# UNITED STATES PATENT AND TRADEMARK OFFICE

10/539,628

<b>Office Action Summary</b>	<b>Application No.</b> 10/539,628	<b>Applicant(s)</b> HINNAH ET AL.	
	<b>Examiner</b> SAMUEL C. WOOLWINE	<b>Art Unit</b> 1637

## **DETAILED ACTION**

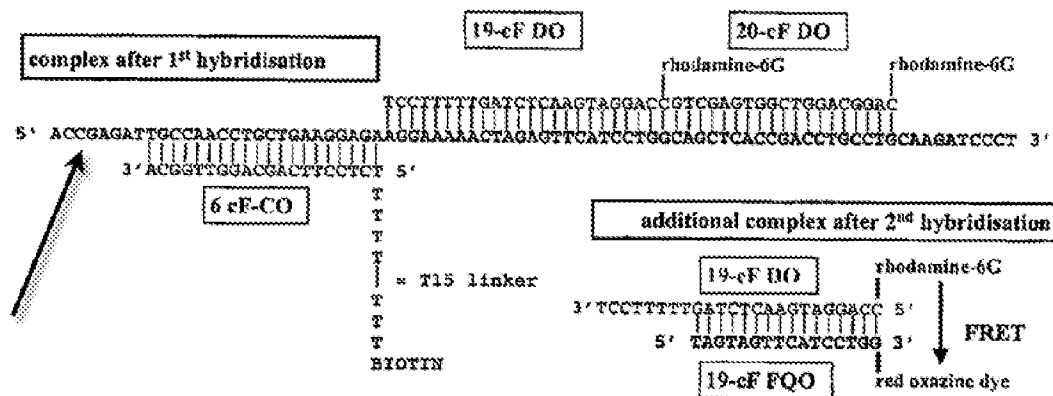
The drawings are objected to because figure 4 contains nucleic acid sequences not identified with sequence identifiers. 37 CFR 1.821(d) states:

With regard to Applicant's amendments to the specification to provide SEQ ID NOs in the description of figure 4, these amendments are acceptable. However, there are two problems. First, the sequence indicated by the arrow below still has no SEQ ID NO either in the figure or in the description of the figure:

Second, the sequence indicated as 19-cF FQO in the figure was ascribed SEQ ID NO:44 in the amendment to the specification made on 04/01/2009. However, according to the sequence listing, SEQ ID NO:44 has the sequence: tagagttcatctgg, whereas the sequence in the figure is: tagTagttcatctgg (where the capitalized T is not found in SEQ ID NO:44). This would appear to require a correction to the sequence listing, as well as the addition of the other sequence (indicated by the arrow above) to

the sequence listing if it is not already present therein. In any event, the drawing is still not in compliance with 37 CFR 1.821(d). The examiner has no objection to an amendment to the specification such as was made on 04/01/2009 in lieu of a correction to the figure itself. However, since the sequence indicated by the arrow above does not have a convenient label in the figure as do the other sequences, it is not clear how this amendment should be made.

Corrected drawing sheets in compliance with 37 CFR 1.121(d) are required in reply to the Office action to avoid abandonment of the application. Any amended replacement drawing sheet should include all of the figures appearing on the immediate prior version of the sheet, even if only one figure is being amended. The figure or figure number of an amended drawing should not be labeled as "amended." If a drawing figure is to be canceled, the appropriate figure must be removed from the replacement sheet, and where necessary, the remaining figures must be renumbered and appropriate changes made to the brief description of the several views of the drawings for consistency. Additional replacement sheets may be necessary to show the renumbering
